DESCRIPTION:
Ltr notarized 3-8-74, re their 11-30-73, 12-31-73, & 1-25-74 ltr.....furnishing addl info to Tech Spec 3.5.2, regarding rev rod withdrawal limits.....w/atcmts.....

PLANT NAME: Oconee Units 1 & 2

Re: Oconee Nuclear Station
Units 1 and 2
Docket Nos. 50-269 and -270

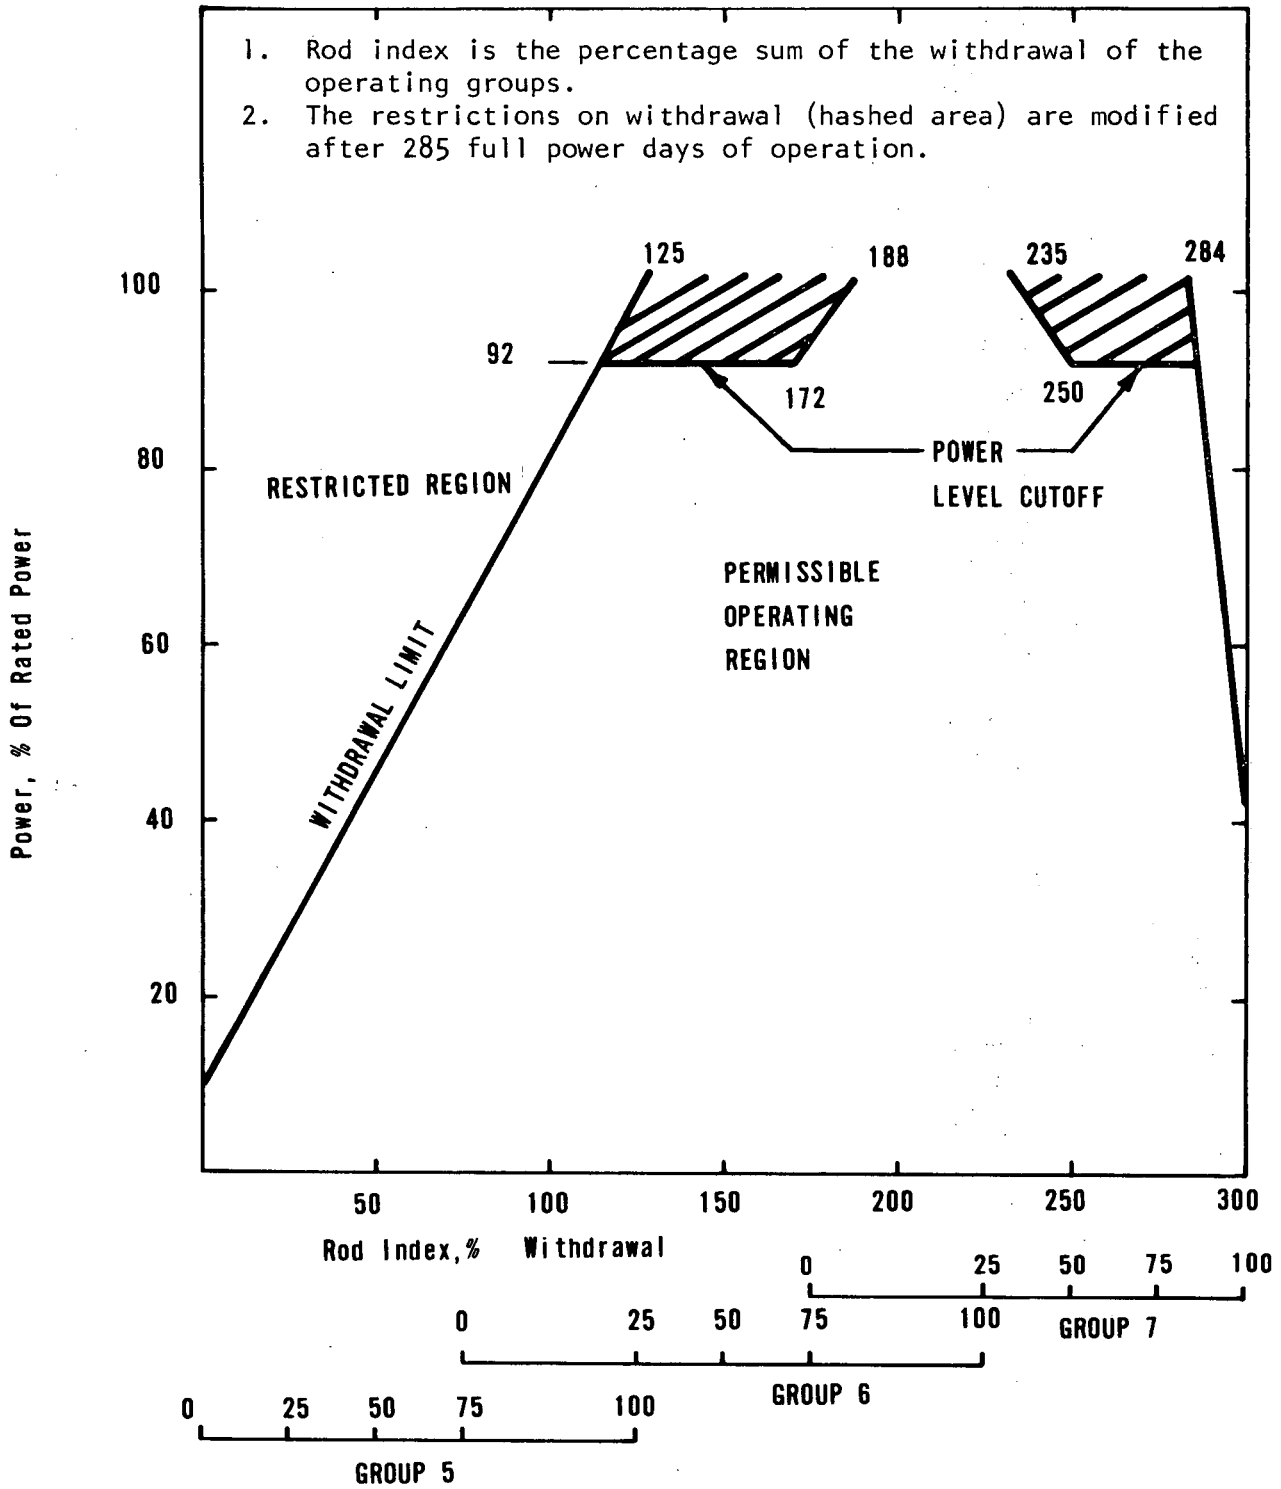
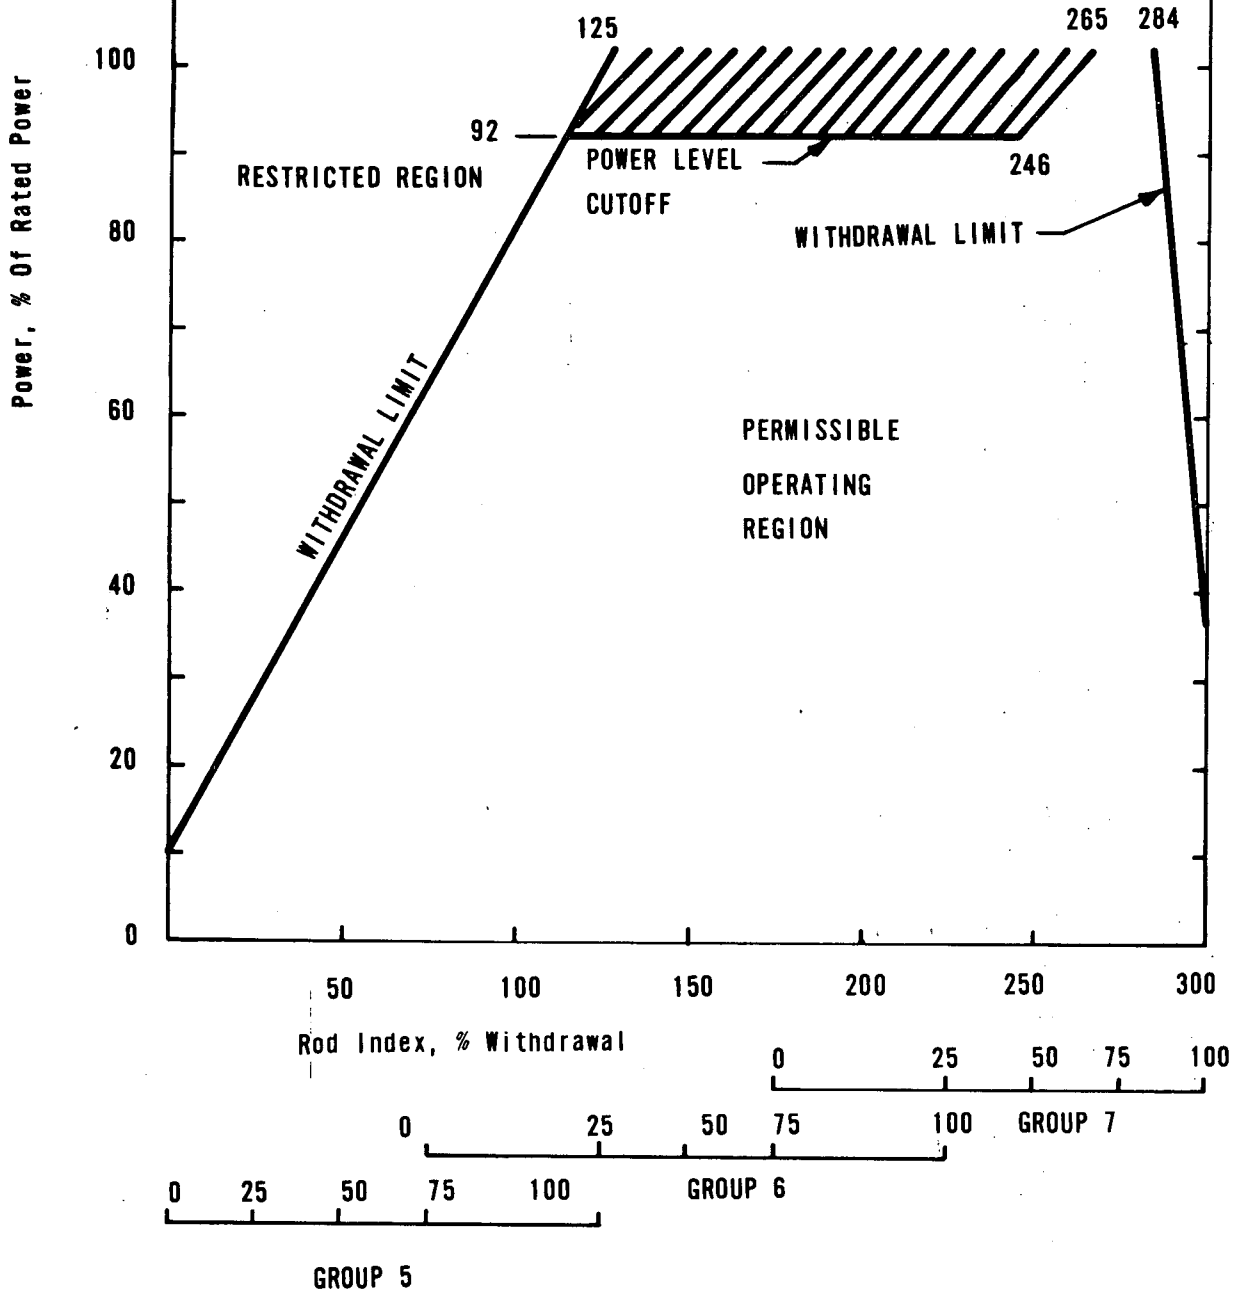
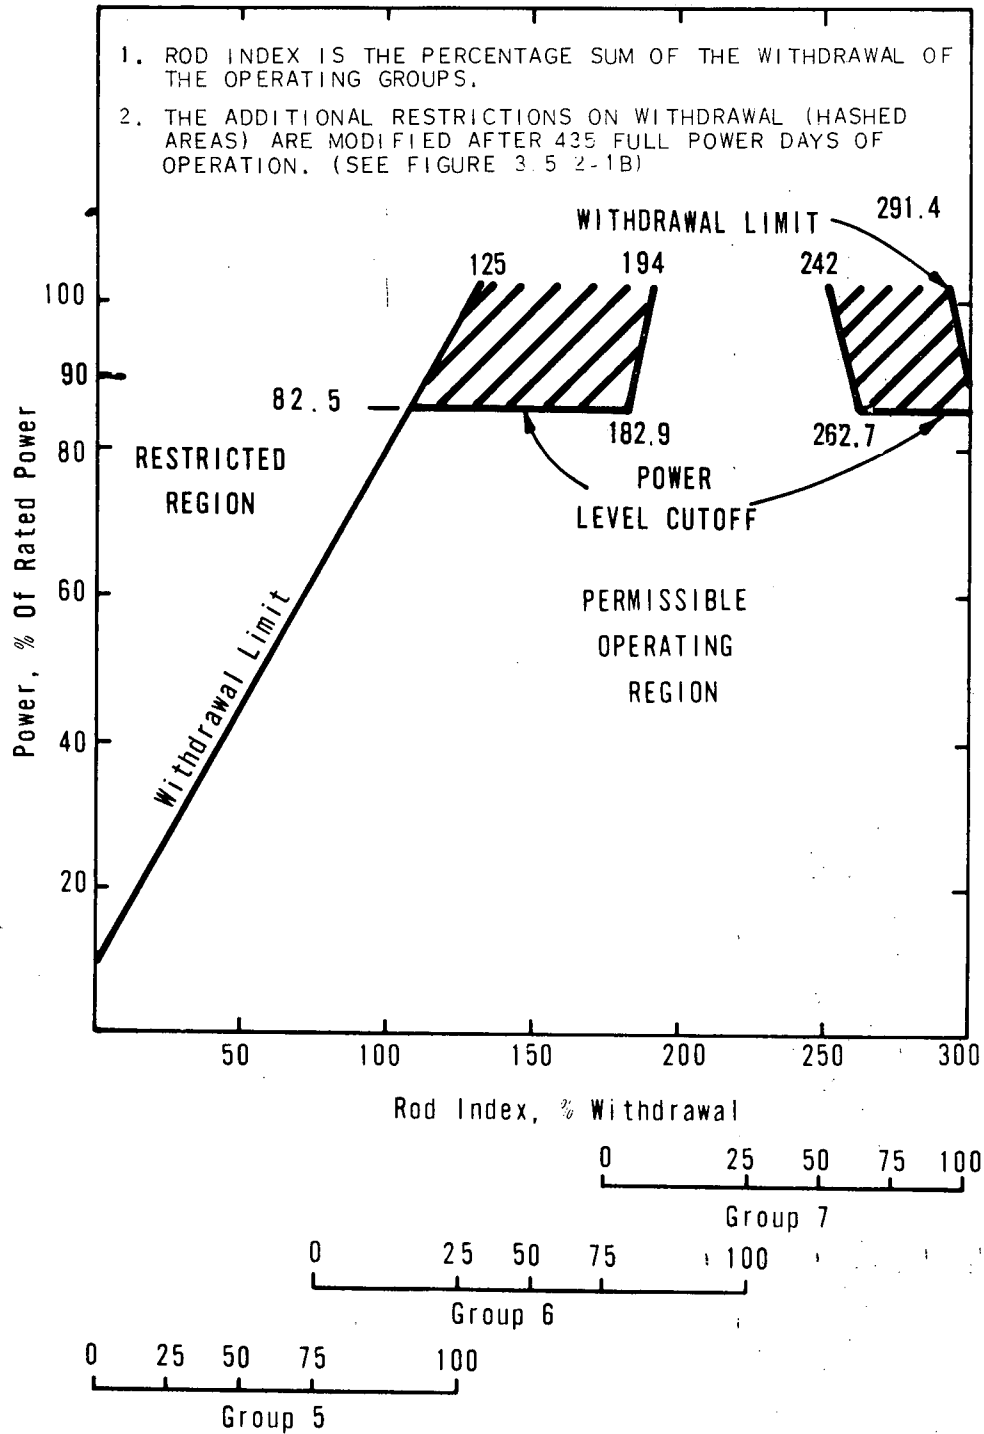
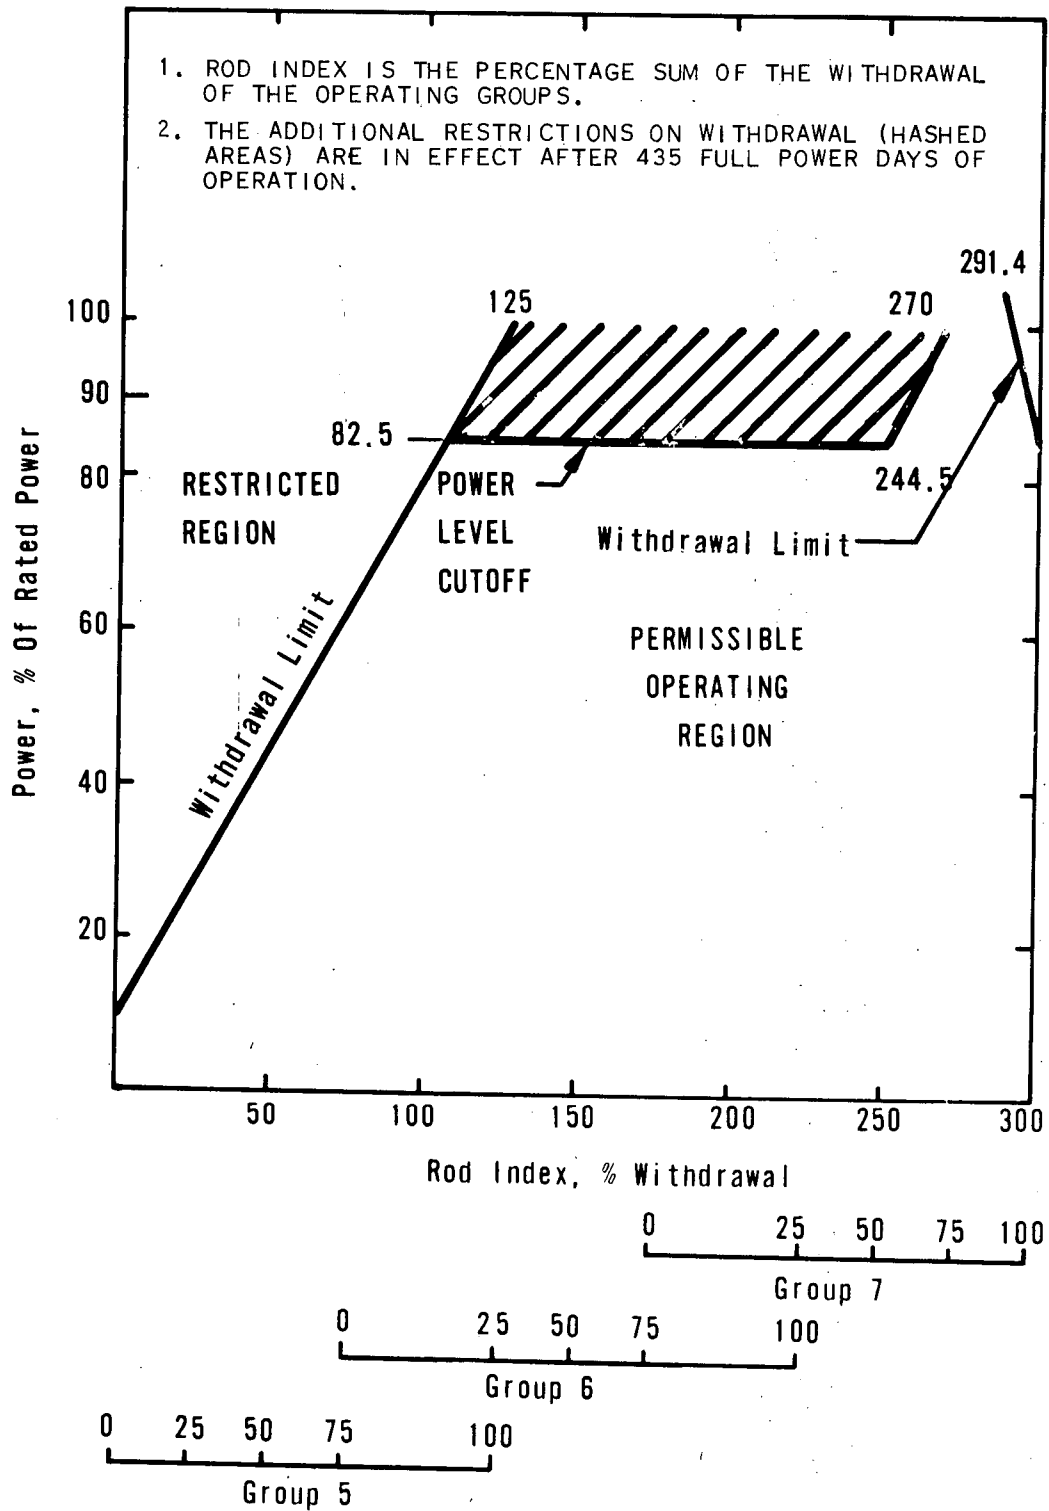
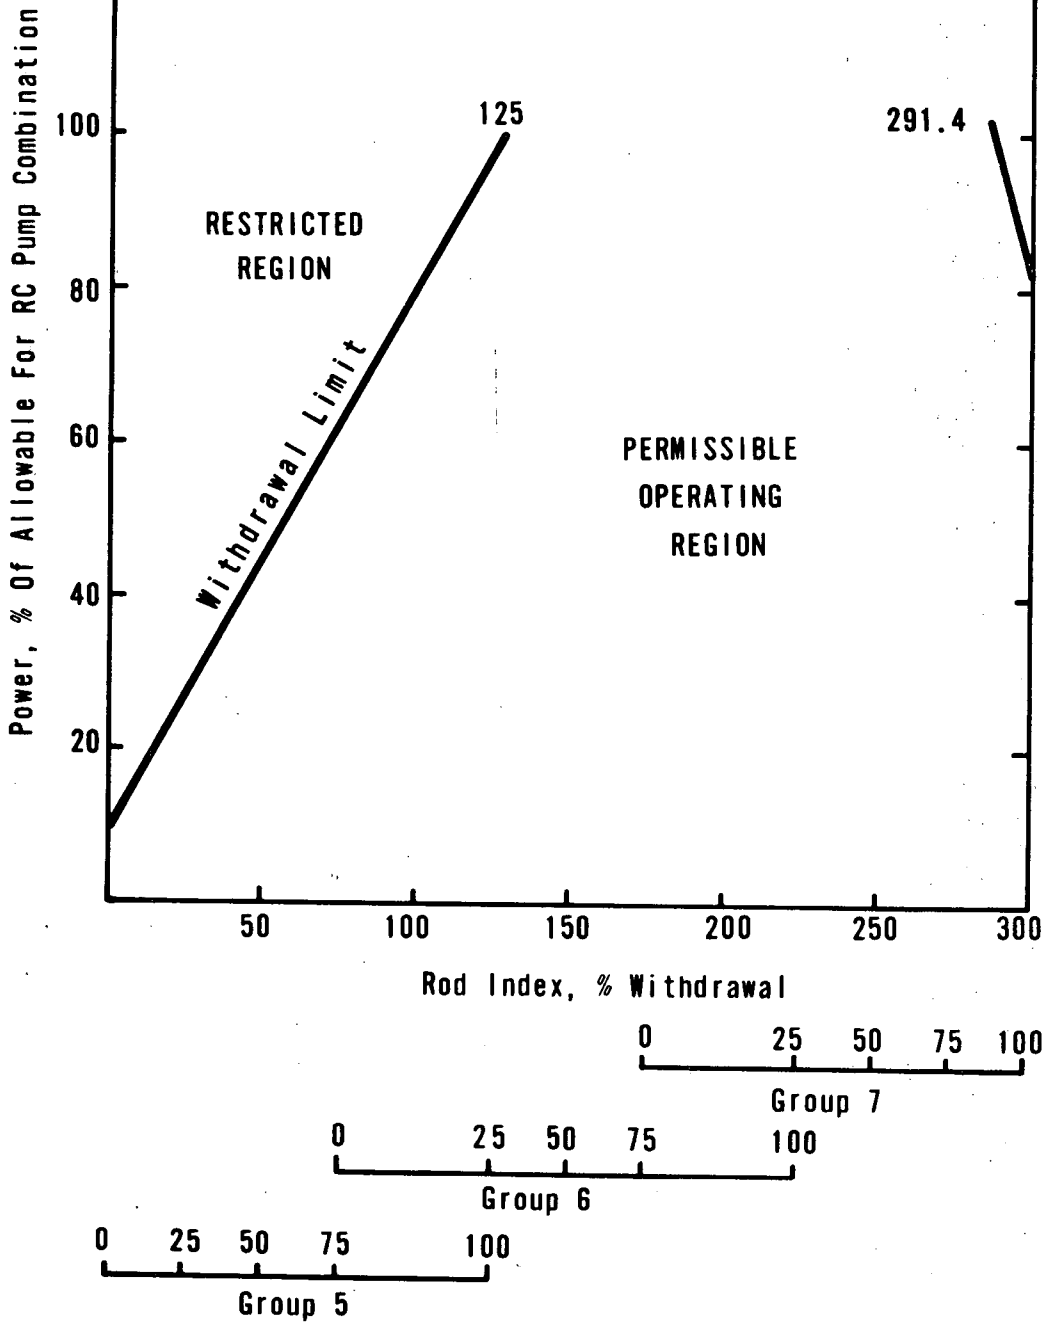
Please refer to my letters of November 30, 1973, December 31, 1973, and January 25, 1974 to you and Mr. J. F. Mallay's letter of February 21, 1974 to Mr. Al Schwencer. In my letters of November 30 and December 31, we requested certain changes to the Oconee Units 1 and 2 Technical Specifications. These changes involved Technical Specification 3.5.2 and principally revised rod withdrawal limits for both Units 1 and 2.

A reanalysis of the Oconee 1 and 2 operating margins with respect to the revised LOCA limit curve was performed by B&W using the procedures developed in BAW-10078. This analysis shows that the revised LOCA limit could have been exceeded assuming licensed design conditions early in plant life. However, based on Oconee 1 and 2 operation, these design conditions are known to be conservative and to exceed their limits and would have required the simultaneous existence of several "worst case" uncertainties. A review of operating data shows that the actual experienced quadrant power tilt for Unit 1 and the achieved power level for Unit 2 preclude the Interim Acceptance Criteria being exceeded. In order for Oconee 2 to operate within the revised LOCA limit and to more accurately reflect the operating characteristics of Oconee 1 and 2 experience to date, revised technical specifications are attached. As identified in my letter of November 30, 1973, increased flexibility in power maneuvering over the existing approved technical specification is provided by a reduction in quadrant power tilt. The attached technical specifications for Unit 2 supersede those attached to my letter of December 31, 1973.

- c. Except for physics tests or exercising control rods, the control rod withdrawal limits are specified on Figures 3.5.2-1A1, 3.5.2-1B1, 3.5.2-1A2, and 3.5.2-1B2 for four pump operation and on Figure 3.5.2-2A and 3.5.2-2B for three or two pump operation. If the control rod position limits are exceeded, corrective measures shall be taken immediately to achieve an acceptable control rod position. Acceptable control rod positions shall be attained within four hours.
- d. Except for physics tests, power shall not be increased above the power level cutoff (see Figures 3.5.2-1) unless the xenon reactivity is within 10% of the equilibrium value for operation at rated power and asymptotically approaching stability.
